## 7.2 Potential Impacts and Mitigation Measures (1, 3)

### QUEENSLAND COKE AND POWER PLANT PROJECT EIS SUPPLEMENT

Figure: 9.1

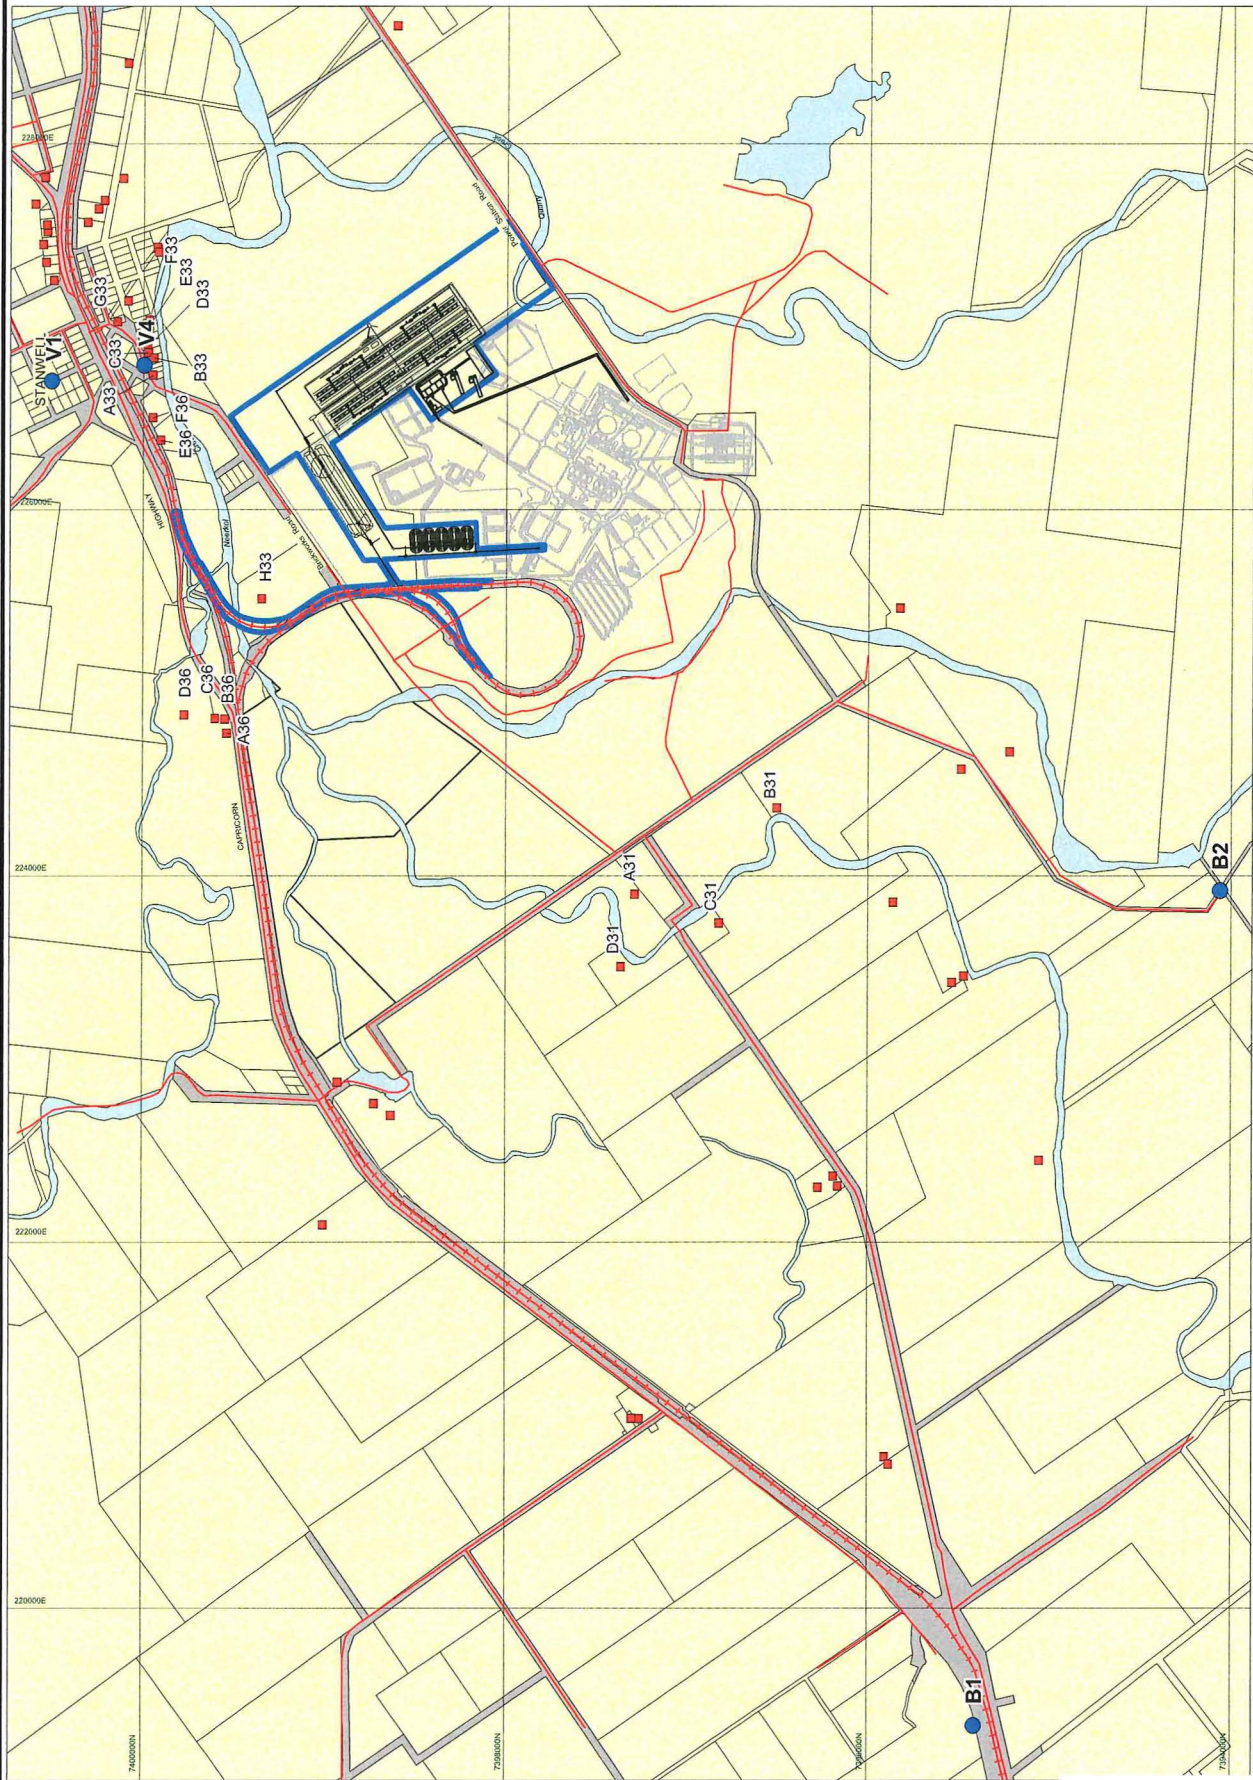
*EPA recommends that the EIS should re-evaluate the potential for stack roar to cause noise impacts based on expected coke plant process gas flows.*

Figures 9.1 and 9.2 present the revised noise contours for the Project along with potential receptors for neutral and inversion conditions respectively. The residences denoted as red squares in these figures are classified as 'rural-residential'. Other properties zoned as 'residential' are located in the Stanwell township. Table 9.2 shows the predicted noise levels for the residences shown in Figures 9.1 and 9.2. The last two digits for each residence refer to the night-time noise limit. A comparison of these figures indicates that the predicted Leq noise levels under inversion conditions are somewhat higher than those predicted under neutral conditions, typically by 5 dB(A) in Stanwell, as expected.
